ATTACHMENT 2

DETAILED ASSESSMENT

The site which is the subject of this Planning Proposal is 5-9 Gordon Avenue (known as SP 57091), containing 15 strata apartments.

Figure 8– Street Frontage Heights and Setback

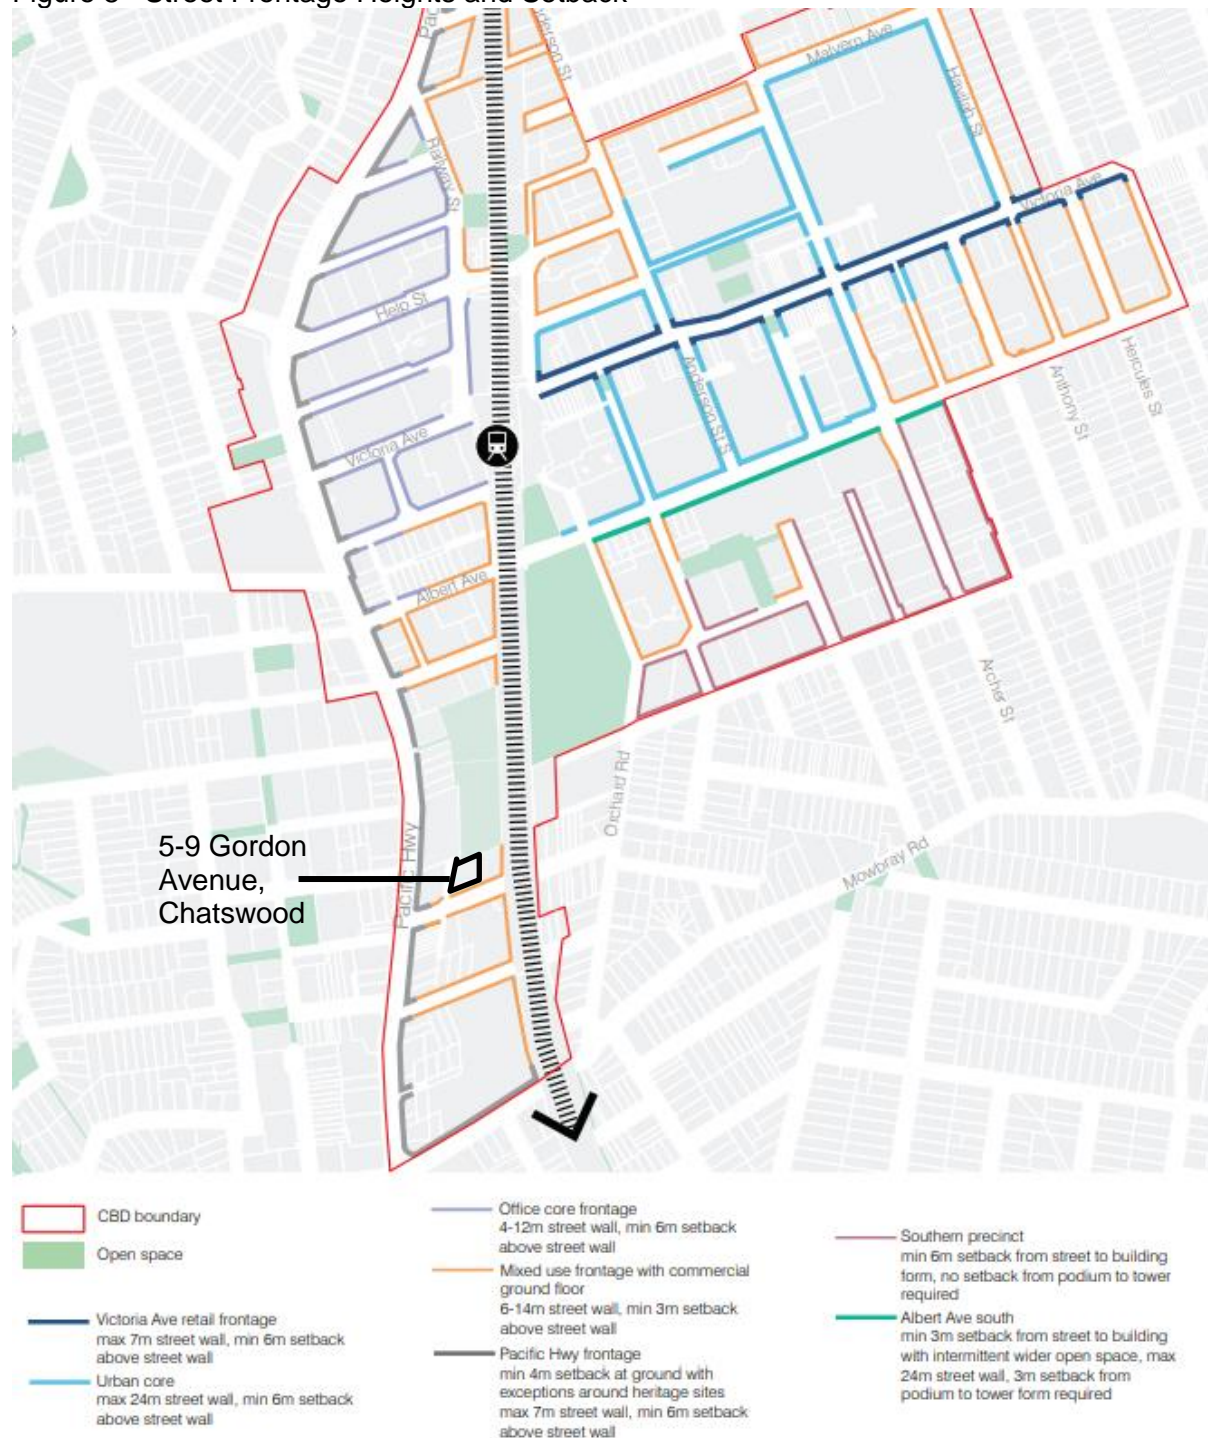
A mixed use frontage with commercial ground floor is required to have a 6m to 14m street wall, height and a minimum 3m setback above street wall, as shown in Figure 8 – Street Frontage Height and Setbacks below.

The Concept is consistent with the Strategy with 3m to 4m podium setbacks and 6m tower setbacks.

With regard to Key Element 27, it is considered that the Planning Proposal is consistent with the *Chatswood CBD Planning and Urban Design Strategy*.
